# Modification Recommended Service Note

## N8928A - Autoranging System DC Power Supply, 500V, 60A, 10000W, 208 VAC

Serial Numbers: DE14290000 - DE15369999 without manufacturing ID Version "B"

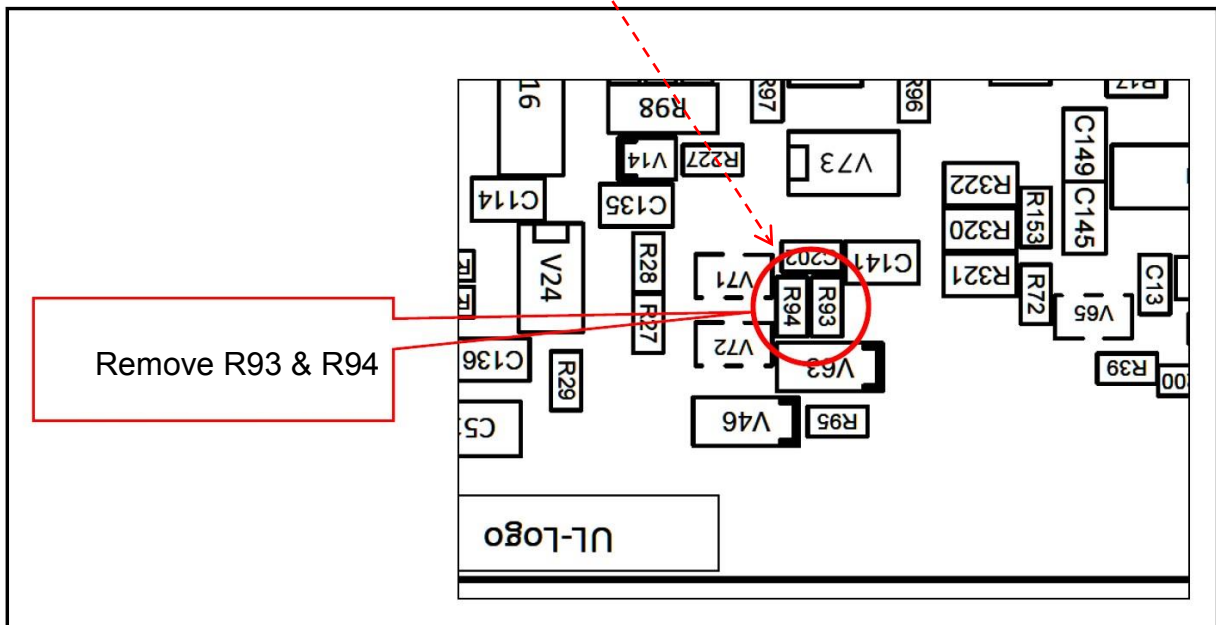
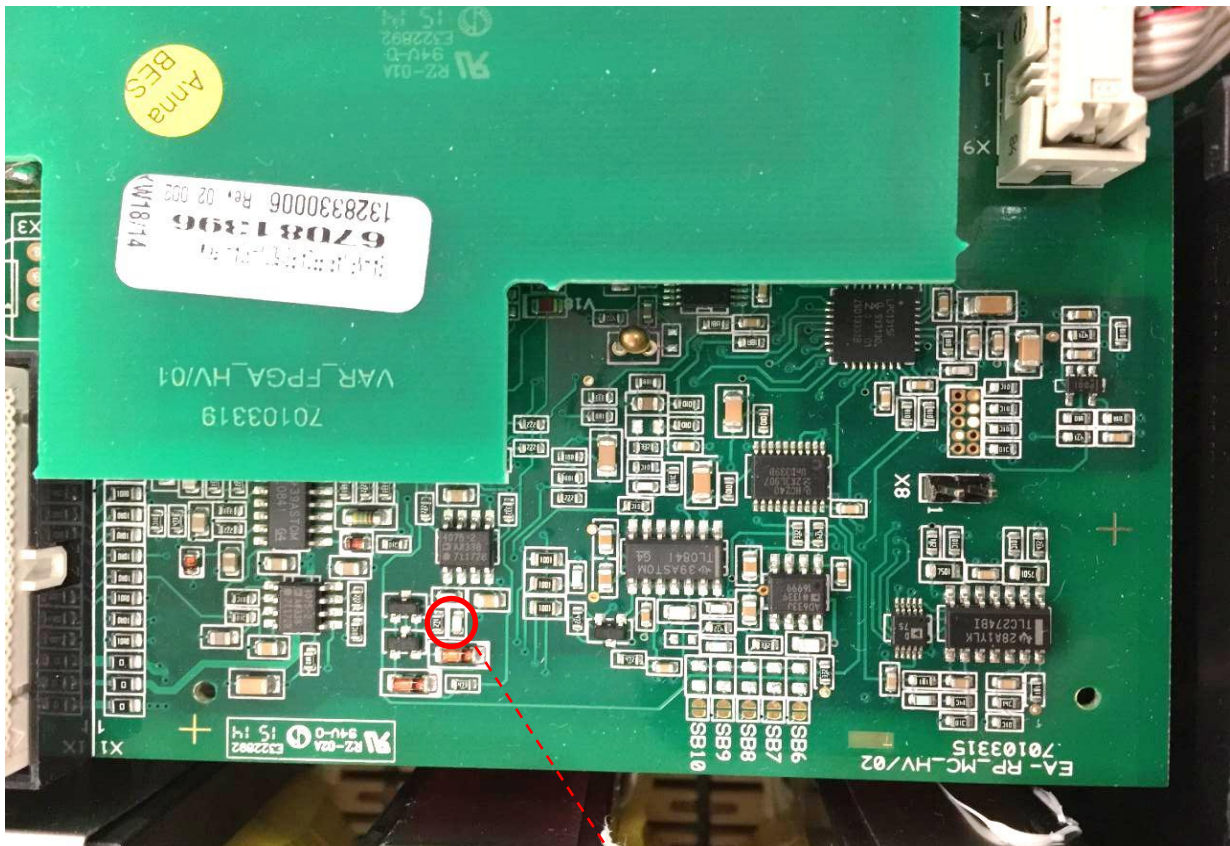
- 1) Remove acMains cable from power source.
- 2) Wait 5 minutes
- 3) Remove top cover from instrument.
- 4) In the 5kW units (viewed from the front of the unit), a small SMT assembly located at the right-rear of instrument will be readily visible (see below):

In the 10kW & 15kW units; although found in the same location, a black plastic cover will have to be removed to gain visibility and access to the SMT assembly. Plastic cover snaps-on and can be removed with a small screwdriver.

Suffix “B” added

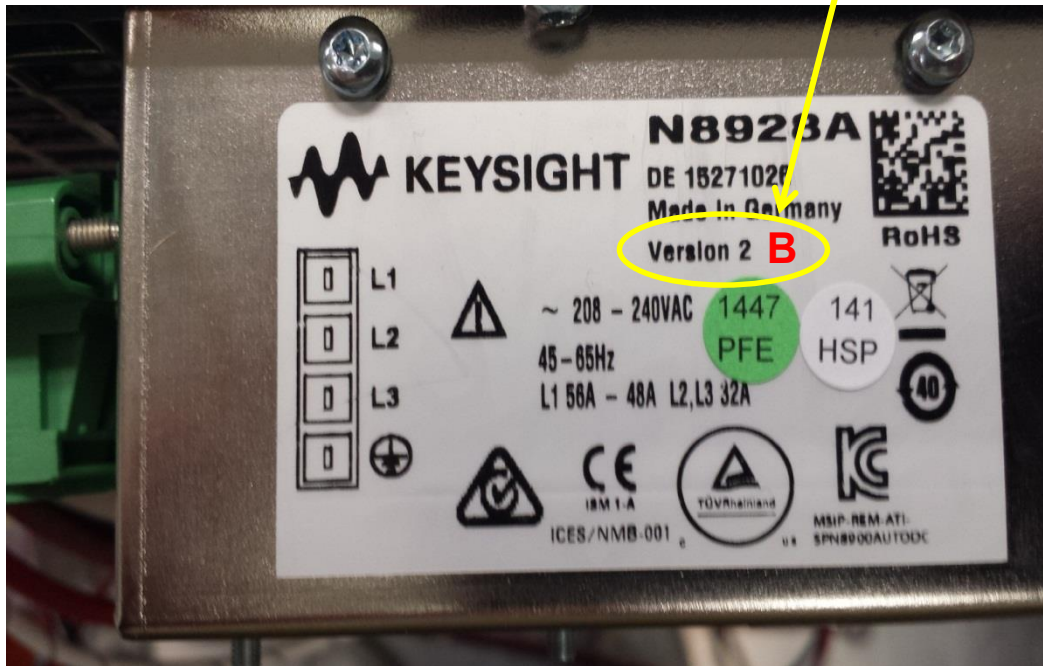
7) On the acMains label, on the rear of the instrument; use an indelible marker, to add the suffix letter “B” after the Version ID. This will assist in the tracking of modified instruments.
